Proposal for amendment of ECE/TRANS/WP.29/GRE/2009/18

The modifications to the current text of ECE/TRANS/WP.29/GRE/2009/18 amendment of Regulation No.48 are marked in **bold**.

Example 9:, amend the figure:

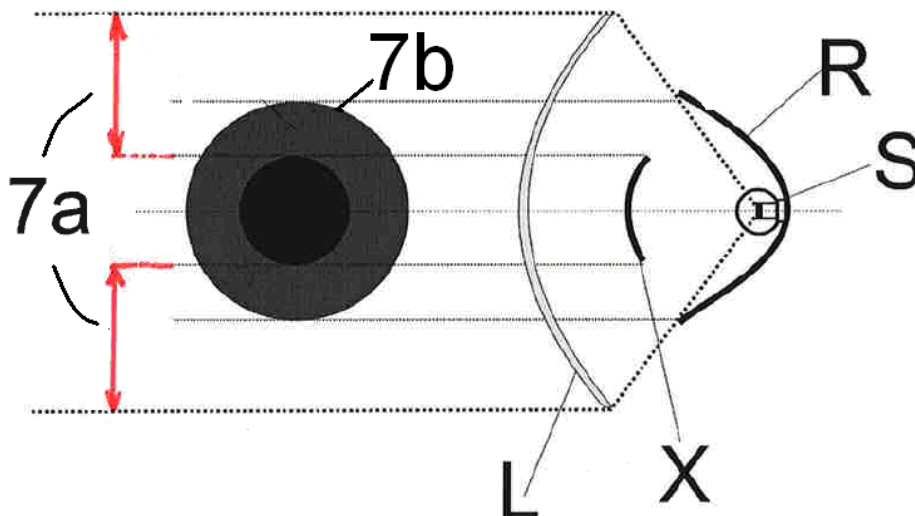
When comparing Example 9 and Example D, the area of light emitting surface contradicts due to different indication when considering the 'X' part.

Example 9 should be amended as above when considering the 'X' part.

Example D: amend the figure

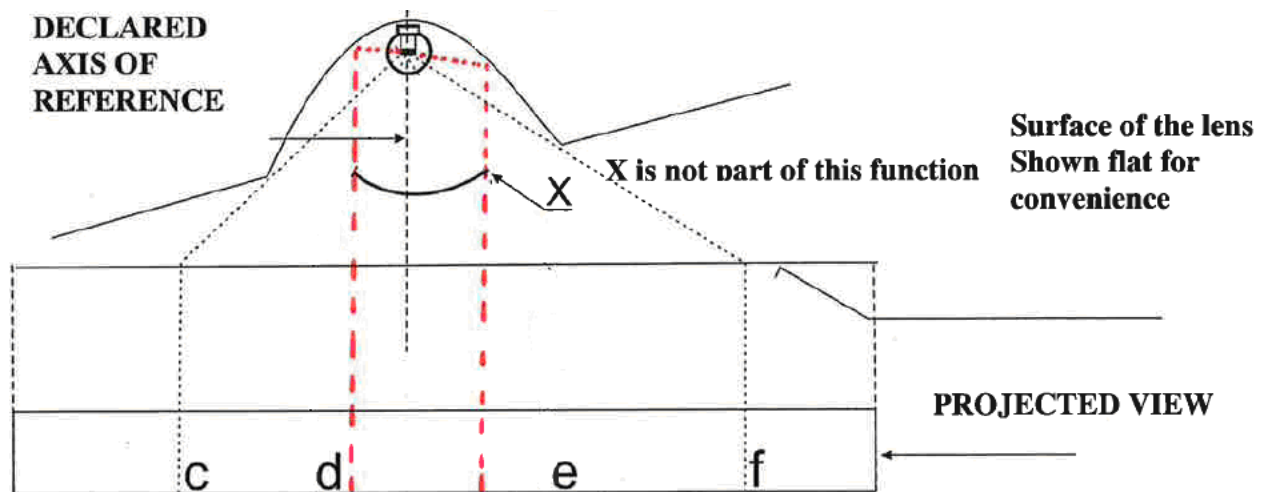
Example D should be amended as above as reflected light should be considered instead of direct light.
